# SAFETY RECALL BULLETIN

## NHTSA RECALL 16V720, Transport Canada TBD

### AUTOCAR, LLC SAFETY RECALL ACX-1604

This document contains information regarding the correction of torque values on the castle nuts of the steering assembly.

**Figure 4**

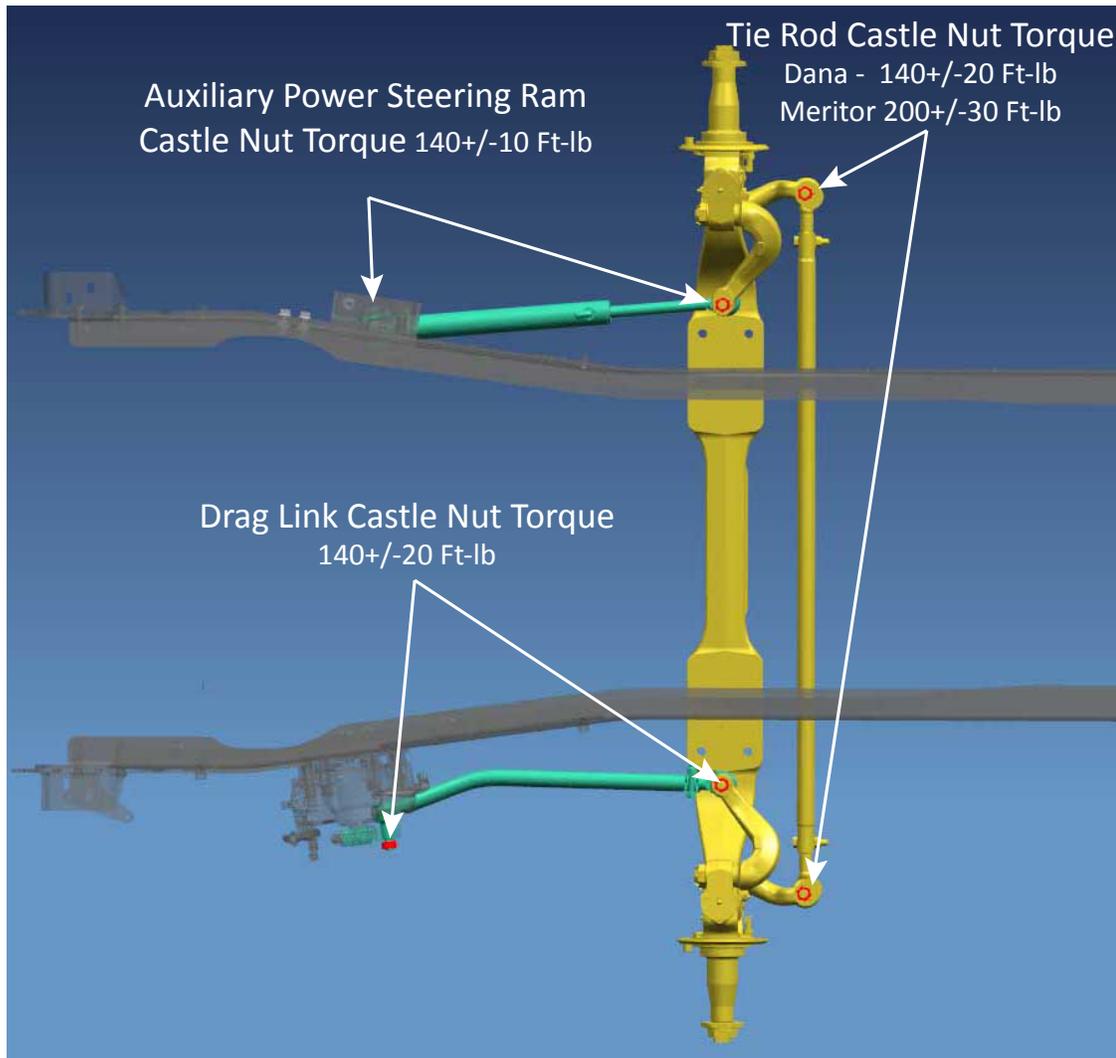
2. Torque each castle nut to the specified torque using the torque values shown in Figure 4 for LH Drive or Figure 5 for RH Drive and in the Torque Chart on page 8.

**Note:** *Tighten all castle nuts to torque specified in chart. If the cotter pin hole is not visible, increase torque until hole is visible.*

Torque Chart				
Component	Thread Size	Socket Size	Ft-lb	+/-
Power Ram Castle Nut	7/8"-14	1 5/16"	140	10
Drag Link Castle Nut	7/8"-14	1 5/16"	140	20
Dana Tie Rod Castle Nut	7/8"-14	1 5/16"	140	20
Meritor Tie Rod Castle Nut	7/8"-14	1 5/16"	200	30
